# Access Compliance Report

## Public Rights-of-Way

### (Pedestrian Signals)

Intersection ID: N/A	Main Street:	Cross Street: N/A	Location: N/A
ADA ID: FAA34FB00ADC	Signal Type: One Push Button-Non APS	Overall Compliance: No	Severity Score: BTN 1: N/A BTN 2: N/A No BTN: N/A
Codes/Mitigation Info/Possible Solution		Field Measurements/Component Compliance

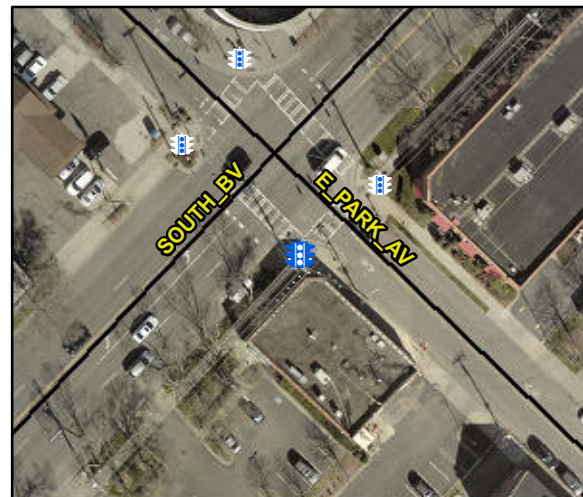
Yes	B 1 Clear Xing Direction?	ClearlyMarked	N/A	B 2 Clear Xing Direction?	N/A
	B 1 Crossing Direction	To NW		B 2 Crossing Direction	N/A
Yes	B 1 DistanceTo XWalk (in)	0.0	N/A	B 2 DistanceTo XWalk (in)	N/A
No	B 1 DistanceTo Curb (in)	87.0	N/A	B 2 DistanceTo Curb (in)	N/A
Yes	B 1 Diameter (in)	2.0	N/A	B 2 Diameter (in)	N/A

Possible Solutions: Replace Signal Push Button With APS Button on New Post. Remove & Relocate Sign.
